**APPLE VALLEY PLANNING DEPARTMENT
PRELIMINARY PLAT REVIEW**

PARCEL ID: AV-1325,1326,1327,1345,1346 & 1348-A

PRELIMINARY PLAT FOR: REDSTONE

PRELIMINARY PLAT REVIEW

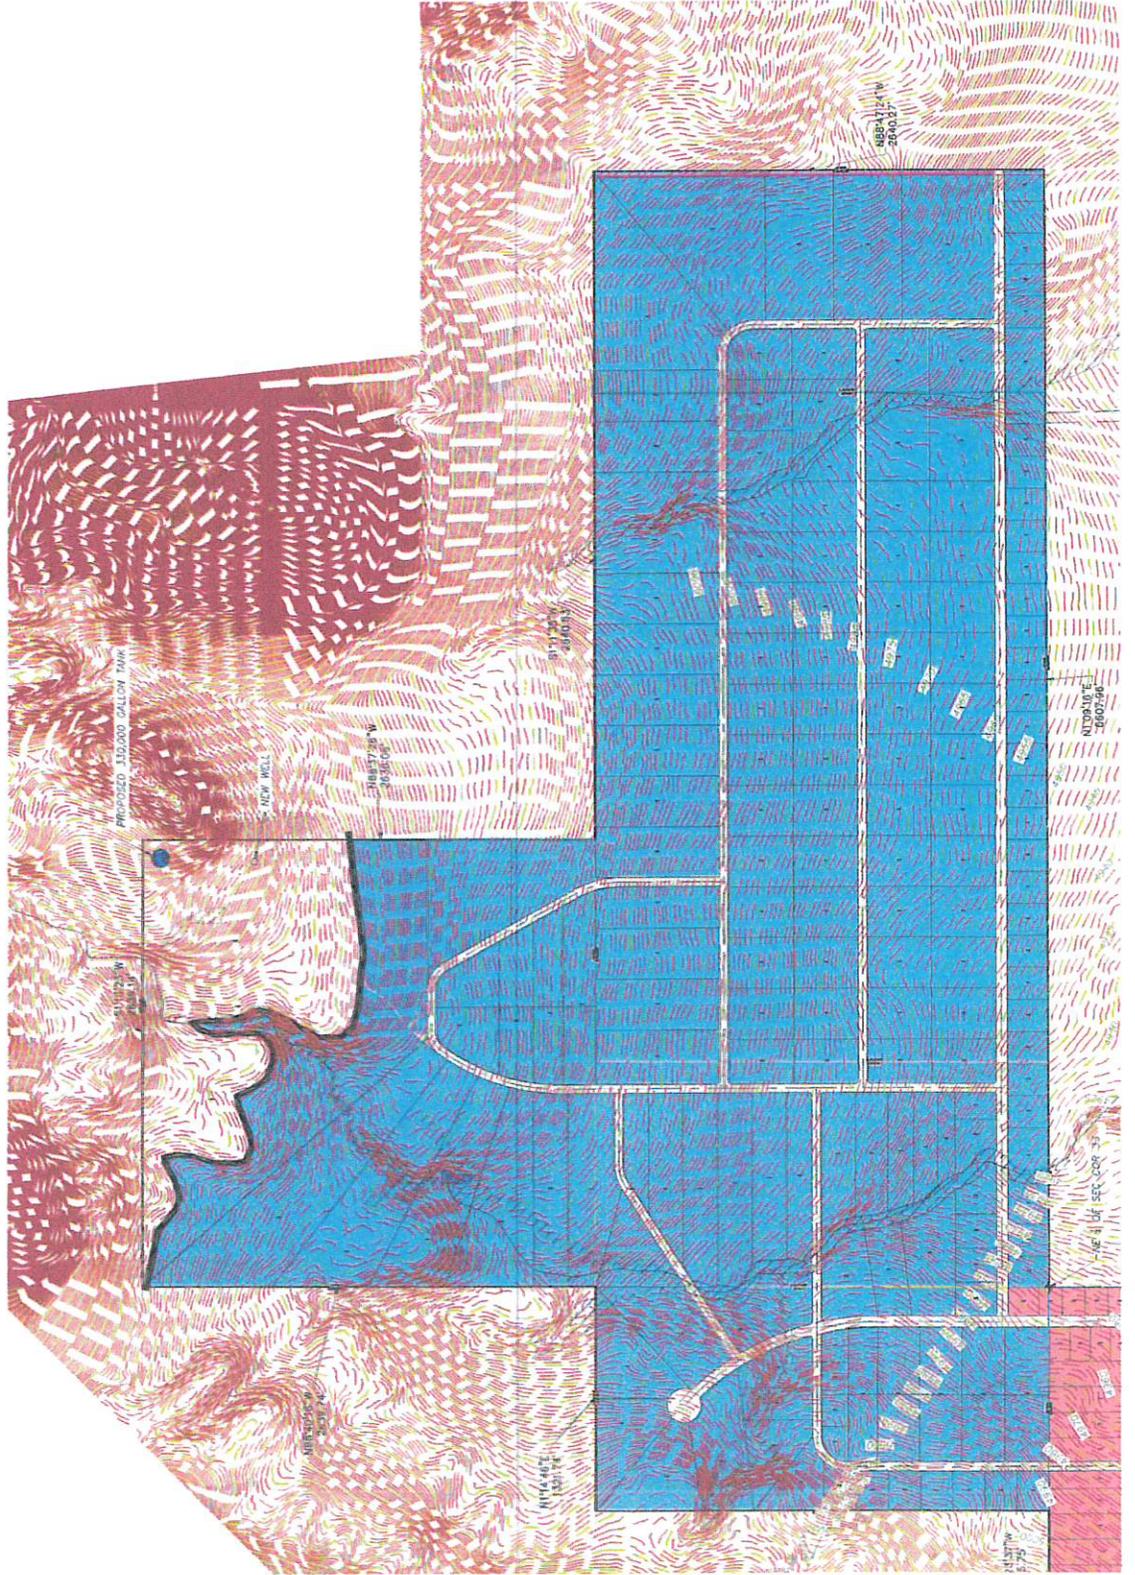
USE THIS

- Is any of the property affected by our Hillside and Sensitive Lands Zoning? YES
- Do all the proposed roads meet town road standards? NO USE TO MAJOR COLLECTOR & 60' RESIDENT, SIDEWALK MISSING ALTERNATIVE

- Are there road connections stubbed out to all adjacent properties and arrangements for temporary turn around shown.
- Does any of the lots have direct access to a Major Collector Road? (Not allowed). YES FIX

- Do any Major Collector roads exceed 8% grade? ? GRADES MISSING
- Is the plat marked with any street grades that exceed 5%? NO
